130 Wellington Street Mosman Park
Proposed Mixed Use Development
Traffic Engineering Peer Review

Prepared for:
Mosman Heights Action Group

August 2021

Prepared for: Mosman Heights Action Group
Prepared by: Paul Ghanous
Date: 5 August 2021
Project number: U21.053

Figure 3: Ground floor loading dock swept path 8.8m truck

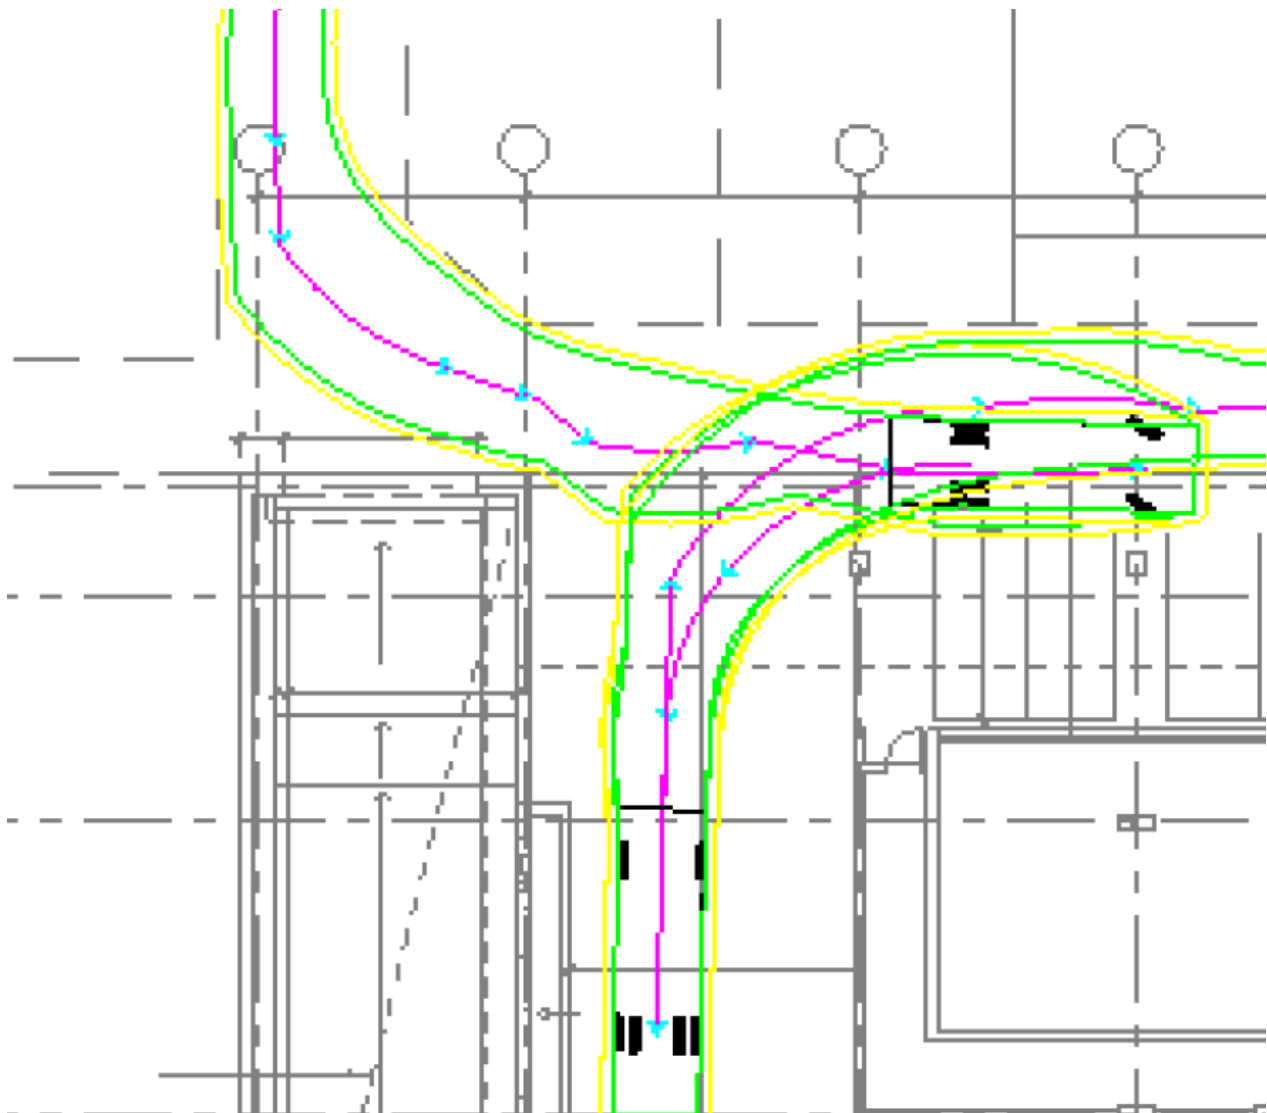
- The swept path sketches presented in the TIA are not scaled, high-quality sketches. The swept path tracking is questionable, showing an unconventional track with wheels being turned at various points to negotiate a single bend (Figure 3). There is also insufficient detail provided regarding the truck template used for the swept path. Review of the TIA swept path indicates the 90-degree bend near the car park ramp on Turnbull Way is very tight for accommodating truck movements.

- *There is insufficient detail provided on the size and frequency of delivery and service vehicles for the proposed development. Given the size and number of tenancies, the largest truck size of 8.8m for the supermarket tenancy and 6.4m for other tenancies seems small. Use of smaller trucks will result in increased frequency of truck movements in Turnbull Way. This will result in reduced amenity for the development and residents.*

- Anticipated schedule, type and frequency of all delivery and service vehicles for the development.
- Proposed management measures.
- Assumed service vehicle dimensions and turning circle specifications.
- Swept path analysis undertaken by a qualified traffic or civil engineer, with no turn wheels from stop and realistic path tracking (no irregular maneuvers in the middle of turns).
- High quality scaled swept path sketches in minimum A3 size format.

Figure 6: Existing intersection of Manning Street / Samson Street

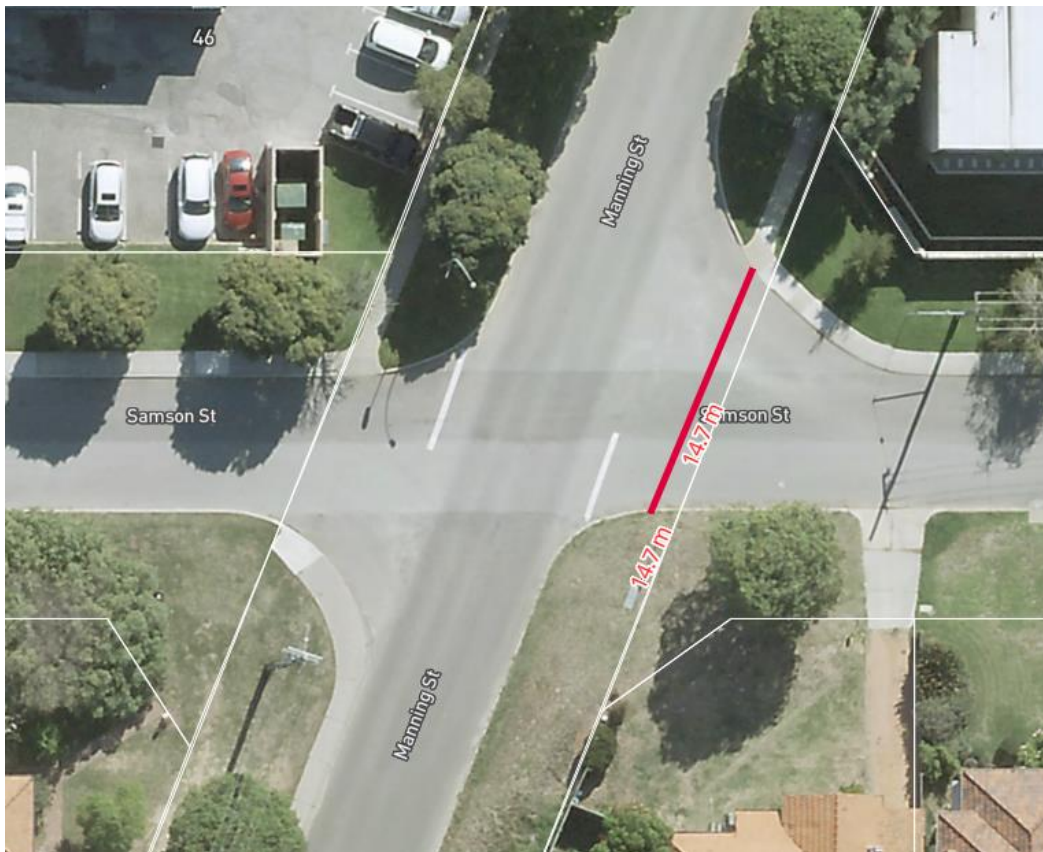
The existing intersection of Manning Street / Samson Street is located at the south-east corner of the subject development site. This intersection, shown in Figure 6, is not configured to contemporary best practice. There is a four-way intersection, with no roundabout treatment. The minor road legs of Samson Street do not intersect Manning Street at a 90-degree angle. The kerb radii are very large and promote high turning speeds for vehicles. The pedestrian crossing distance is quite large, for example almost 15m on the eastern leg. The pedestrian kerb ramp on the eastern side of Manning Street leads pedestrians into the intersection, with no ramp or footpath continuation on the other side of Samson Street.

Safe systems engineering would require some modifications or treatments at this intersection. Ideally, a roundabout would be provided, which will control vehicle approach speeds in all directions of travel, define right of way and improve potential crash angles to achieve safer outcomes.

Alternative treatments may include raised threshold treatments at the intersection and tightening of kerb radii, which was also touched on in the TIA.
